From: Andrew Dutton-Parrish [mailto: [REDACTED]]
Sent: 11 June 2017 23:05
To: Henry, Kate [REDACTED]
Subject: ref. 2017/2471/ P 15 Lyndhurst Terrace NW3 5QA.

Report

Subject: Trees in the garden and the effects of proposed building work at no.15.

Reference: 15/114

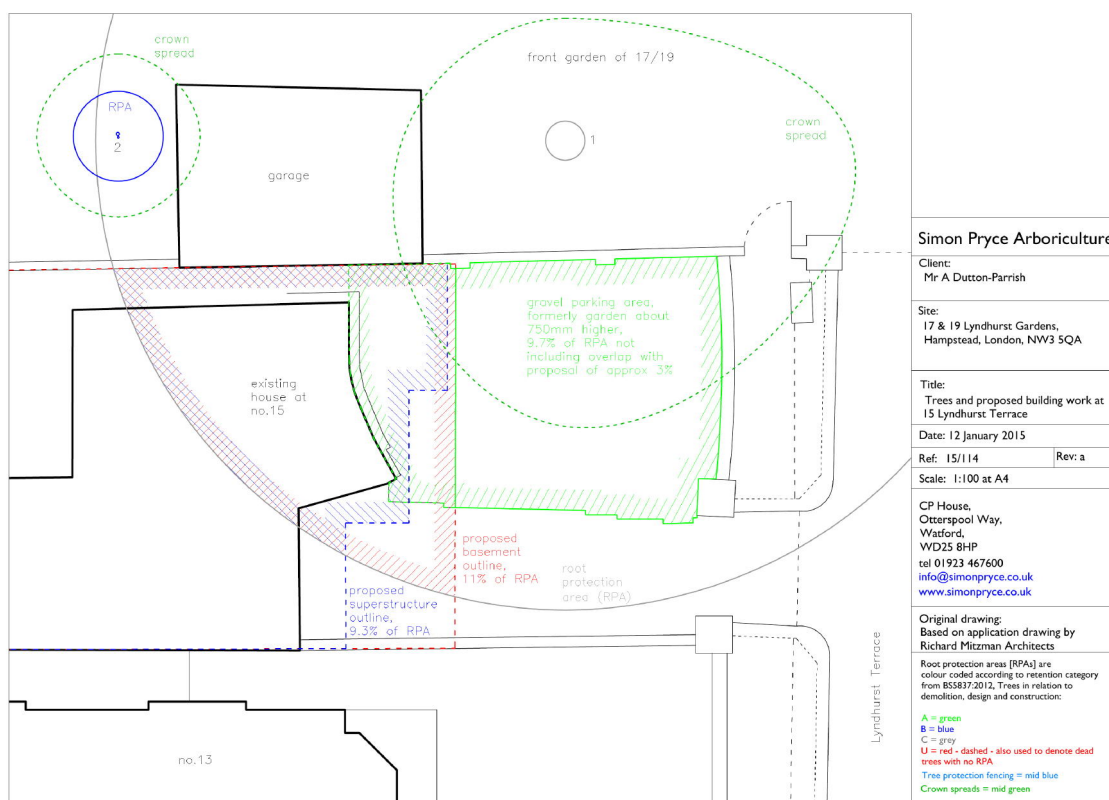
- 4.9 A substantial part of the tree's RPA is under the front garden of no.15 and the boundary wall is unlikely to be deep enough to be a barrier to root growth, so it will have been affected by recent changes there as well as the proposed works. The tree would have been present when the ground level in the front garden was raised by depositing the topsoil. During the 50 or so years that the soil was present was present roots will have grown into it and, as they need air as well as water, they are likely to have proliferated at the expense of the deeper roots. The area concerned is about 53m² or about 12.7% of the RPA although, as the area has been resurfaced, it is not possible to tell exactly what the effect on the roots was.

- 4.10 The tree was not in leaf when inspected but from the appearance of the twig growth it has tolerated the removal of the soil. However the basement footprint takes up about 11% of the RPA. There is some overlap with the former raised garden, so the overall incursion into the RPA is just over 20%. A younger healthier tree might tolerate that but, while this one is in reasonable physiological condition for its age, the cumulative effect of the recent and proposed ground work nearby would carry a high risk of harming it significantly. The loss of small feeding roots at the periphery of the root system would reduce its ability to absorb water and nutrients. Most of the main structural roots are within about 3x the trunk diameter, so with this tree these would be within no.17/19 and the work would be unlikely to affect the tree's stability directly. However damage to slightly roots could lead to the tree being colonised by honey fungus, which could kill it or decay the roots, leading to longer term stability problems. The fungus is present in the gardens and is a virulent form that has already accounted for several tree losses.

- 4.11 With a basement there is no possibility of using less damaging techniques, such as piled foundations. However much of the area affected is near the outer edge of the tree's RPA and a substantial part of the new house is outside it completely. Therefore a relatively small reduction in the extent of the nearer part of the new house, such as limiting the extent to the north to match the existing one, would reduce the risk to the tree significantly. However the detailed design of that is a matter for others.

- 5.5 With the basement there is no option of using less damaging foundations, but a relatively small reduction of the extent of the new building towards the tree would lessen the risk to it appreciably.
